Request for Information (“RFI”)

Harrison, Town-Village Recreation Center Phase 2
270 Harrison Avenue
Harrison, NY 10528

ISSUE DATE: ASAP**RFI No.** RFI 044 - Doors & Hardware
Various Questions**PROJECT NUMBERS:** 2020-1005 /**REQUESTED REPLY DATE:**
COPIES TO:**RFI DESCRIPTION:** See attached RFI#01 from Direct Doors**REFERENCES/ATTACHMENTS:** *(List specific documents researched when seeking the information requested.)***SPECIFICATIONS:****DRAWINGS:****OTHER:****SENDER'S RECOMMENDATION:** *(If RFI concerns a site or construction condition, the sender may provide a recommended solution, including cost and/or schedule considerations.)***RECEIVER'S REPLY:** *(Provide answer to RFI, including cost and/or schedule considerations.)*

**Post Submittal RFI #1
Harrison R&C Center
Job #300799**

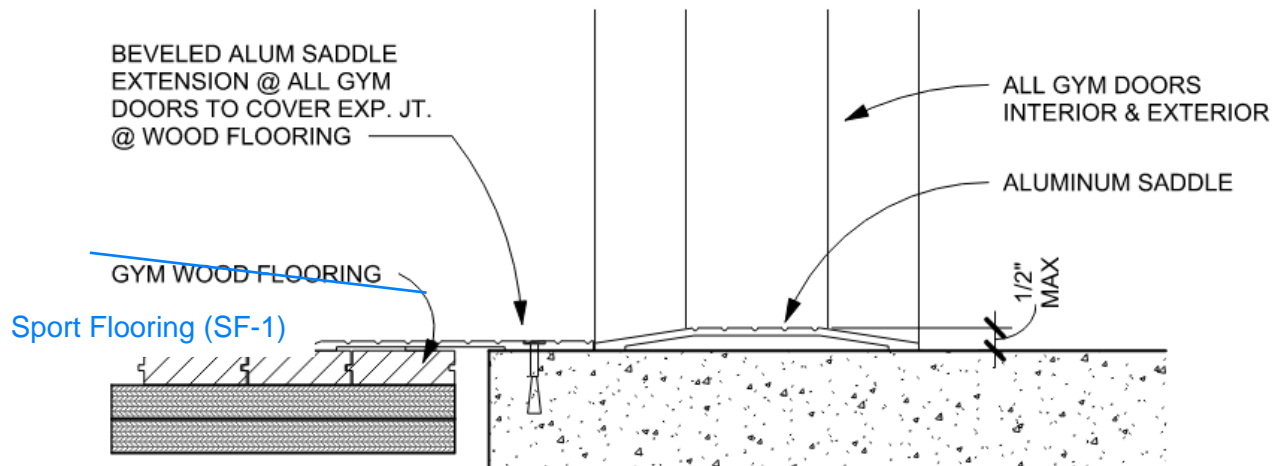
6. **Please Advise:** If door tag C101 is to be treated as right hand swing or left-hand reverse swing opening.

Left Hand reverse, the intent is for that door to be secure from the C103 side. When C101 is locked occupants of the Gym are forced to exit through Stair B.
